**CORRESPONDENCE COVER SHEET
WASTE PERMITS DIVISION
TEXAS COMMISSION ON ENVIRONMENTAL QUALITY**

Date: February 14, 2019
 Facility Name: City of Fort Stockton Landfill
 Permit or Registration No.: MSW 235-C

Re: City of Kingsville Landfill – Kleberg County
Municipal Solid Waste (MSW) - Permit No. 235C
Permit Amendment Application – Notice of Deficiency
Tracking No. 23301130 and 23458984; RN102334570/CN600674246

On behalf of the City of Kingsville and in response to the Texas Commission on Environmental Quality's (TCEQ) December 12, 2018 Notice of Deficiency (NOD) letter, we hereby submit the enclosed response regarding the Permit Amendment Application for the above referenced MSW facility.

FIGURE:
III.1-2

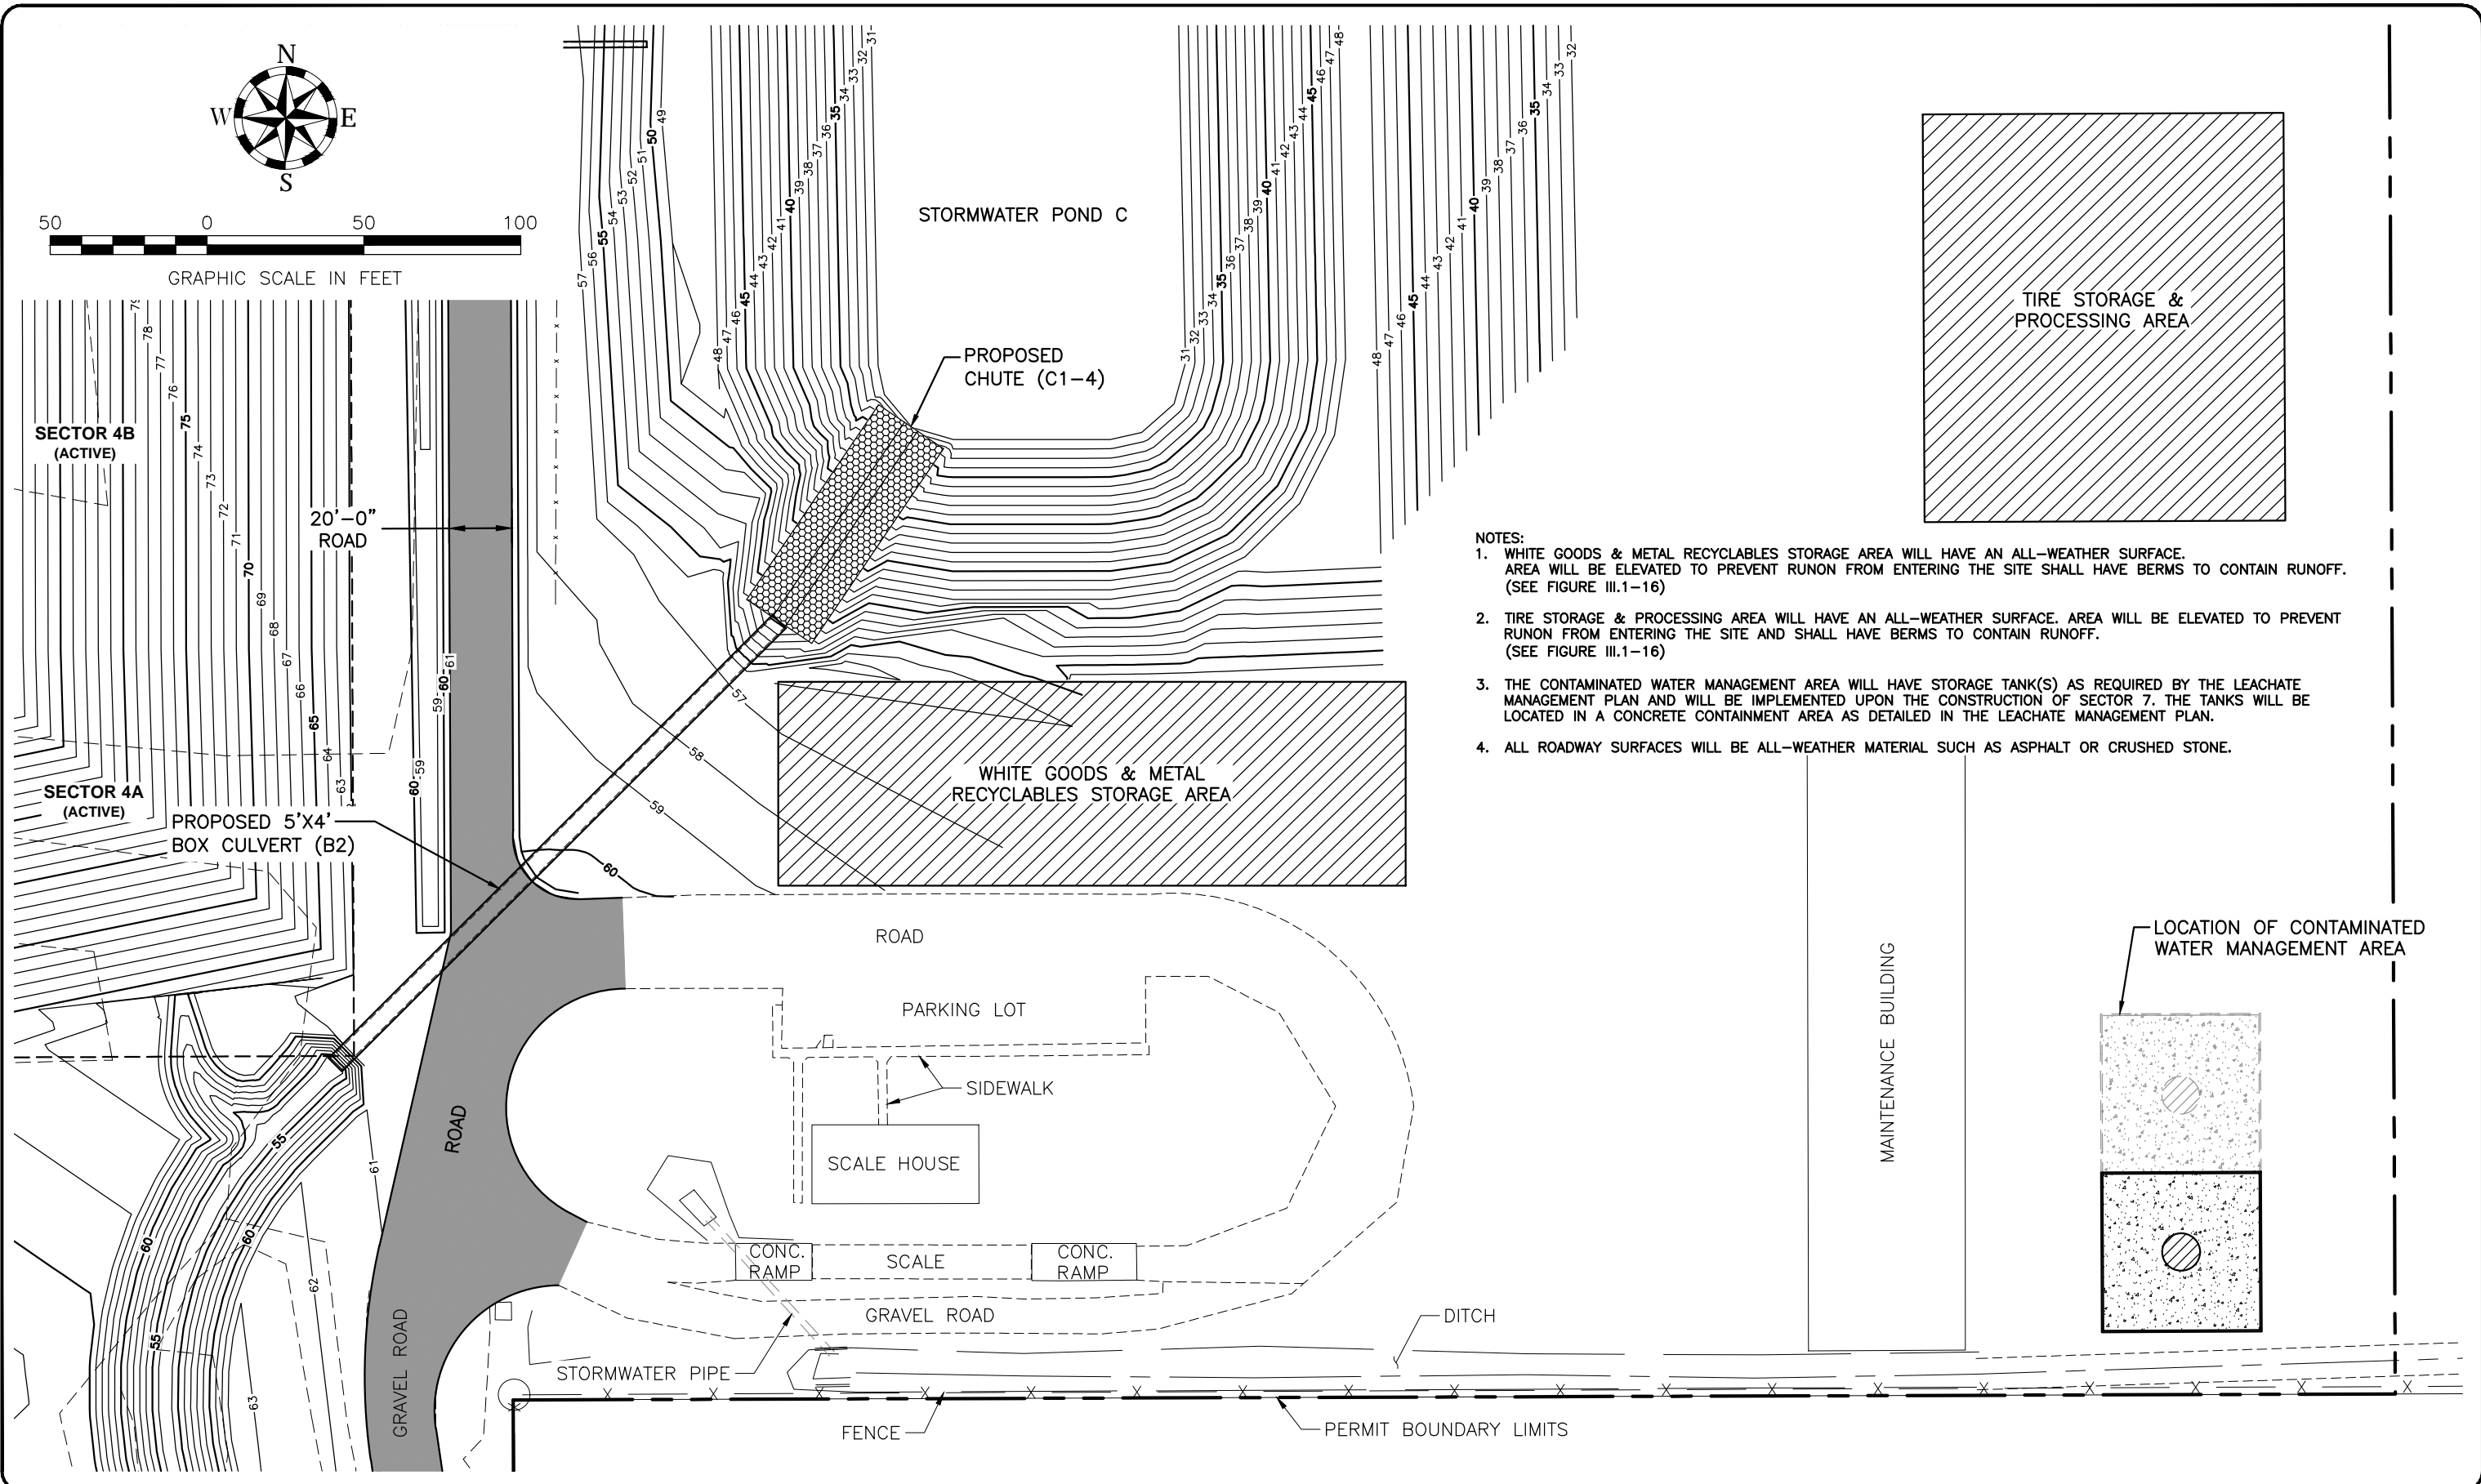
T25	195	Part II	330.61(d)(9)(A)	Vol 1, Part III, Att 1, Fig III.1-2	Incomplete	Indicate the type of waste disposed in each sector	Vol 1, Part III, Att 1, Figure III.1-2 has been revised to Indicate the type of waste disposed in each sector.
NT26	198	Part II	330.61(d)(9)(D)	Vol 1, Part I, Att 2, Fig I.2-1	Omitted		The dimensions of the sectors are provided on Vol 1, Part I, Att 2, Fig I.2-5.
NT27	199	Part II	330.61(d)(9)(E)	Vol 1, Sec 1.2, pg- 1; Vol 5, Part III, Att 7, Fig III.7-1	Omitted		The maximum waste & final cover elevation are indicated on Part III, Attachment 7, Figure III.7-1.
NT28	204	Part II	330.61(h)(1)	Vol 1, Sec 8.2, pg- 10	Omitted		Vol 1, Part II, Sec 8.2, pg- 10 has been revised to include reference to Part II, Attachment 1, Figure II.1-6 - NAS Kingsville Compatible Land Use Zoning Map
T29	233	Part II	330.543(b)(1)	Vol 1, Part II, Sec 1.4, pg- 2	Ambiguous		Vol 1, Part II, Sec 1.4, pg- 2 has been revised to state: "The 50-foot buffer zone will be maintained for previously permitted airspace, while a 125-foot buffer zone will be maintained from the outermost edge of new airspace for the vertical and lateral expansion areas."

FIGURE:
III.2-1

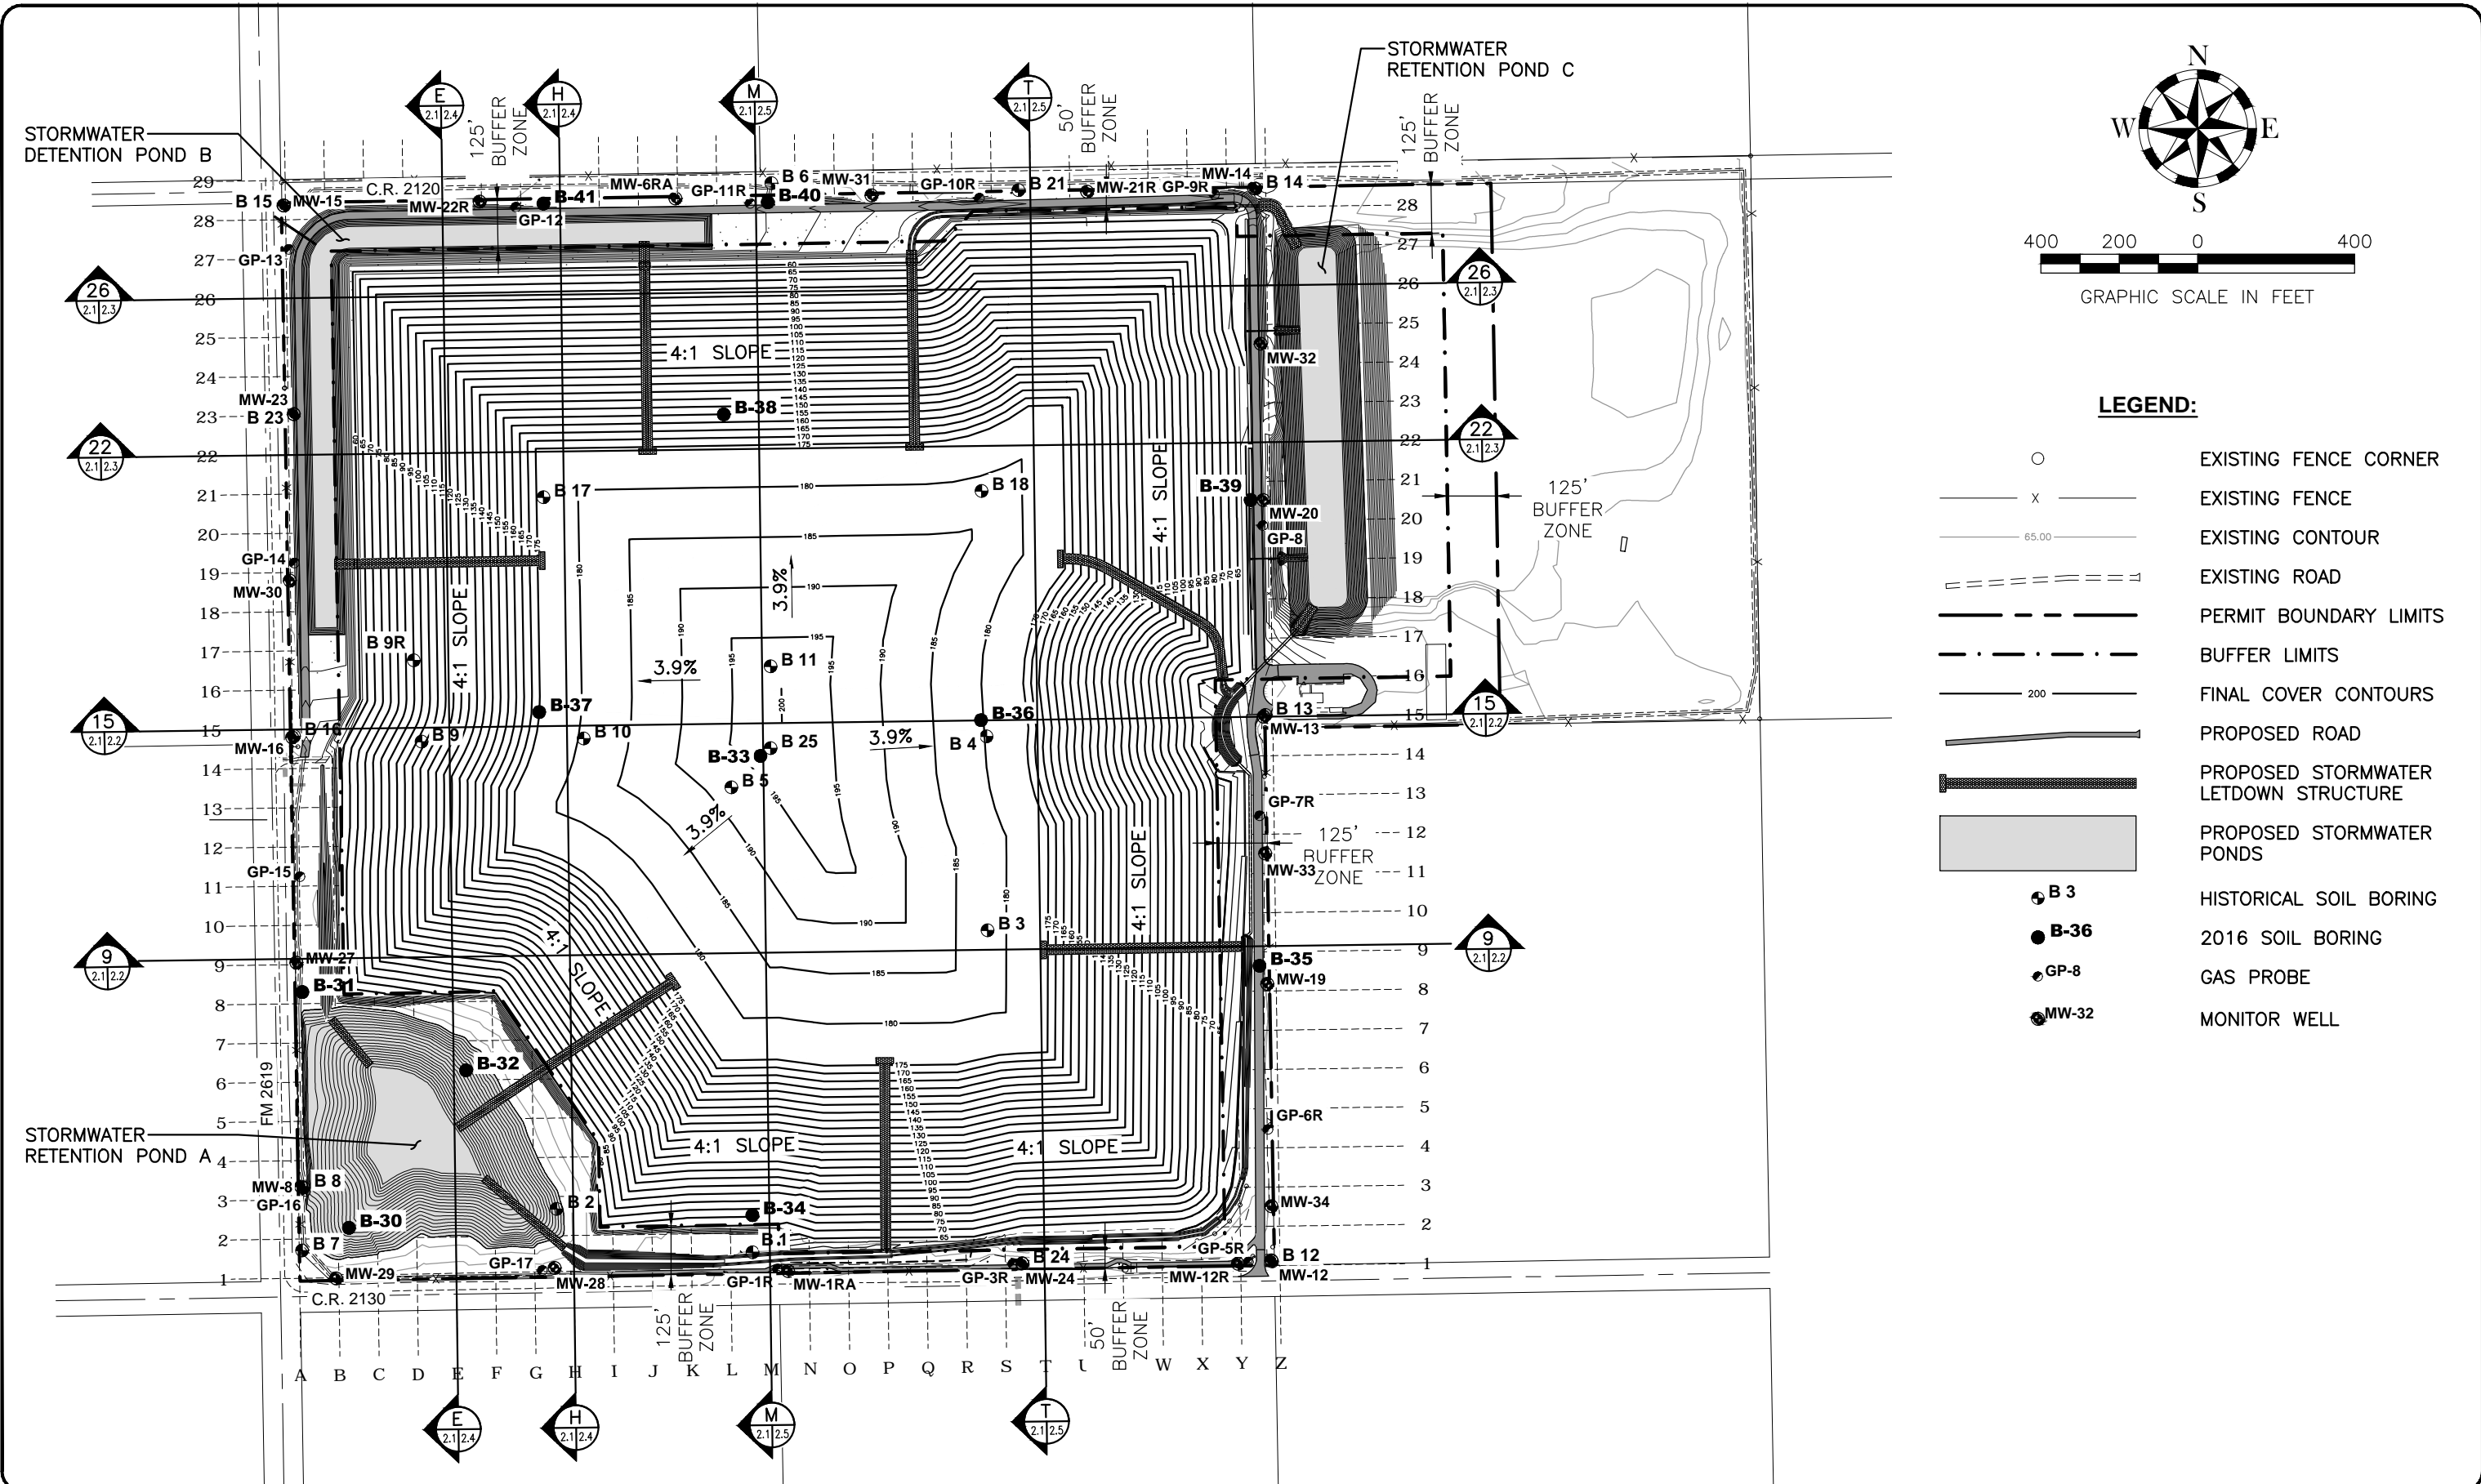
T41	353	Part III	330.63(d)(4)(E)	Vol 1, Att 2, Fig III.2-1 thru III.2-5	Incomplete	Indicate the maximum waste elevation, maximum final cover elevation, and elevation of the deepest excavation; provide sufficient number of cross sections with inset key map; revise Figure III.2-5 to include a Type I overliner over the existing Type IV area.	Figures III.2-1 through III.2-5 in Volume 1, Part III, Attachment 2 have been revised to indicate the maximum waste elevation, maximum final cover elevation, and elevation of the deepest excavation. Figures III.2-2 through III.2-5 in Volume 1, Part III, Attachment 2 have been revised to include an inset key map. The existing Type IV area (Sector 4D) was constructed and approved by TCEQ with an alternative Type I liner, so an overliner is not required. A description of the liner system existing in Sector 4D has been included in Volume 1, Part III, Section 5.5, p.g. 10 and a copy of the TCEQ approval letter of the Liner Evaluation Report is included as Volume 6, Part III, Attachment 16.

T42	353	Part III	330.63(d)(4)(E)	Vol 1, Att 2, Fig III.2-1 thru III.2-5	Incorrect	Revise the incorrect labels of lines and sectors on Figures III.2-2 to III.2-5.	Figures III.2-1 through III.2-5 in Volume 1, Part III, Attachment 2 have been revised to correct mis-labeled lines and sectors.
T43	354	Part III	330.63(d)(4)(E)	Vol 1, Att 2, Fig III.2-1 thru III.2-5	Incomplete	Add cross sections with inset key map depicting all items listed (for MRI IDs 354 through 357).	Figures III.2-2 through III.2-5 in Volume 1, Part III, Attachment 2 have been revised to include an inset key map and to depict the items listed for MRI IDs 354 through 357.
T44	358	Part III	330.63(d)(4)(F)	Vol 1, Att 2, Fig III.2-1 thru III.2-5	Omitted		A detail of the typical perimeter berm construction has been included on Volume 1, Part III, Attachment 2, Figure III.2-3
T45	359	Part III	330.63(d)(4)(G)	Vol 5, Att 10	Incomplete	In Section 1.2, acknowledge the designs are alternative, and reference alternative liner design demonstrations in Attachment 5.	Language has been added to the liner systems discussion in Section 1.2 of Volume 5, Part III, Attachment 10 acknowledging that the liner system designs are alternative liner designs and to reference the alternate liner design demonstrations in Volume 5, Part III, Attachment 5.

Figure 4.14
 Regional Map showing
 Recharge Area
 Geologic Atlas of Texas
 Corpus Christi Sheet - 1975

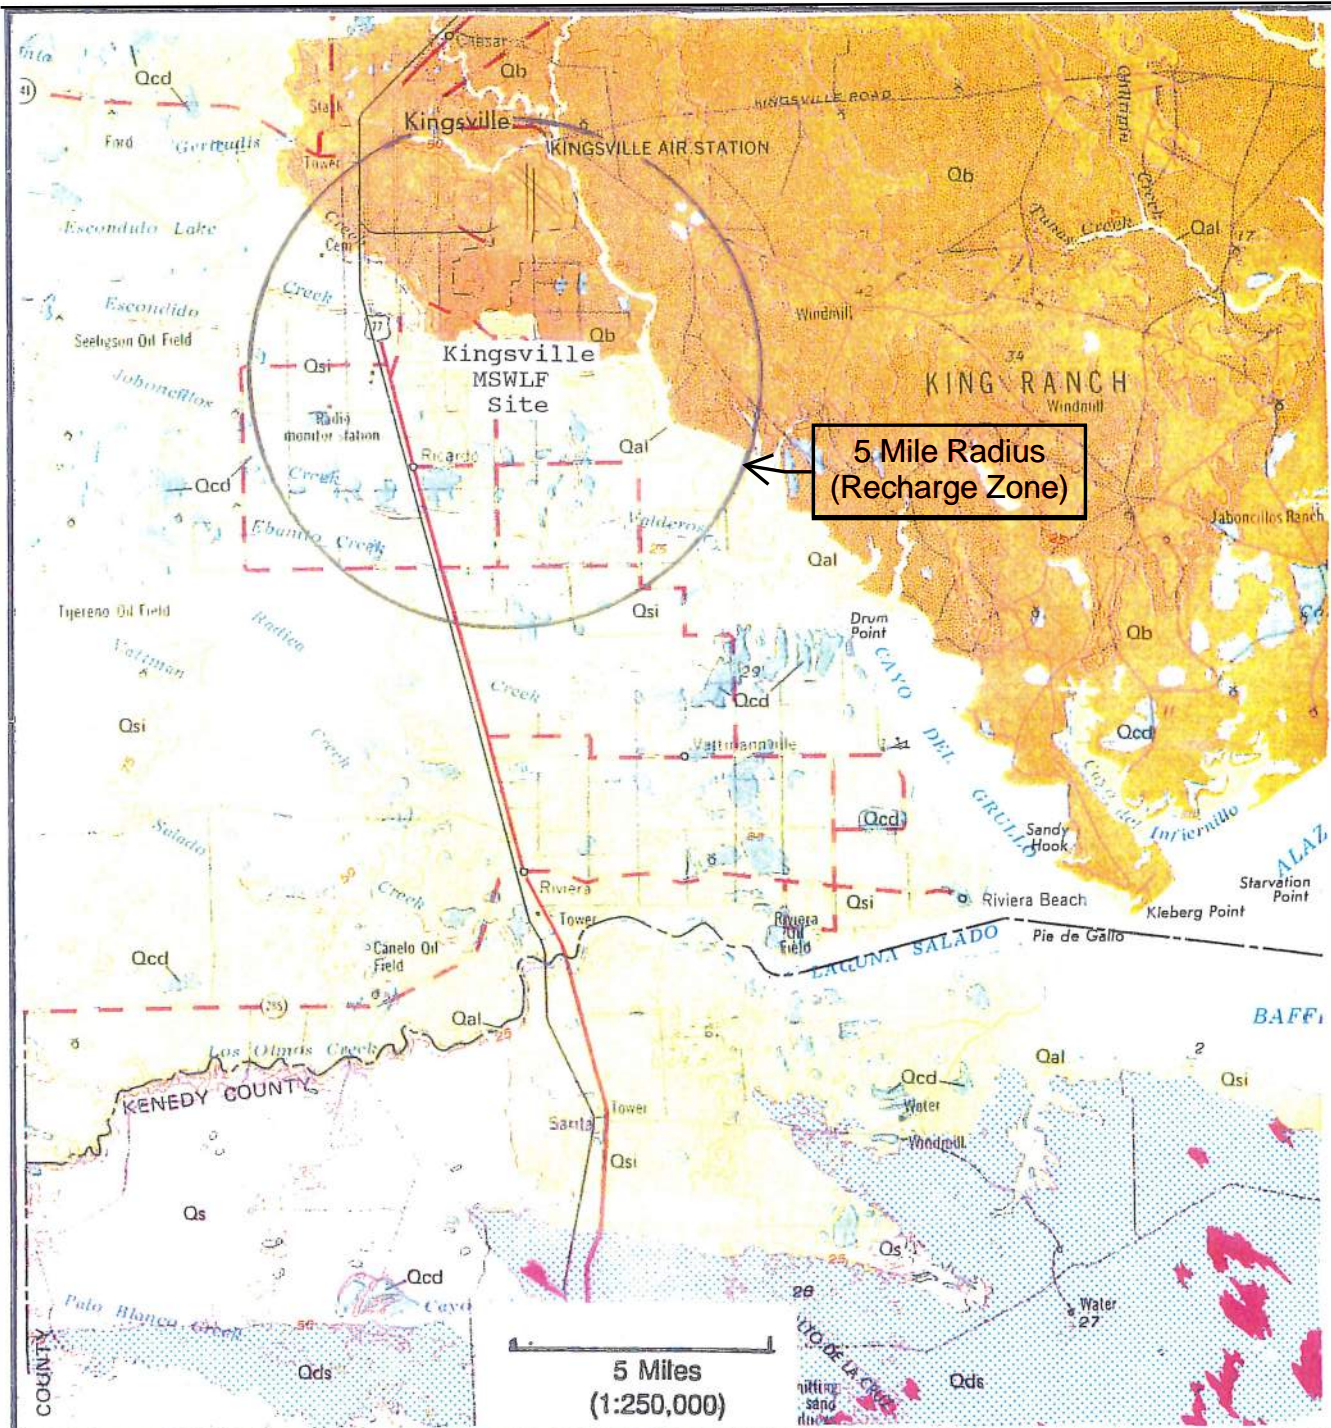
As discussed in Appendix 1 (Section 4.3, Page 37), Recharge within a 5 mile radius is from downward percolation of surface water, infiltration from streams, impoundments, and water retained in abandoned caliche pits. A map of the recharge area can be seen in Figure 4.14 on page 44 of Appendix 1.
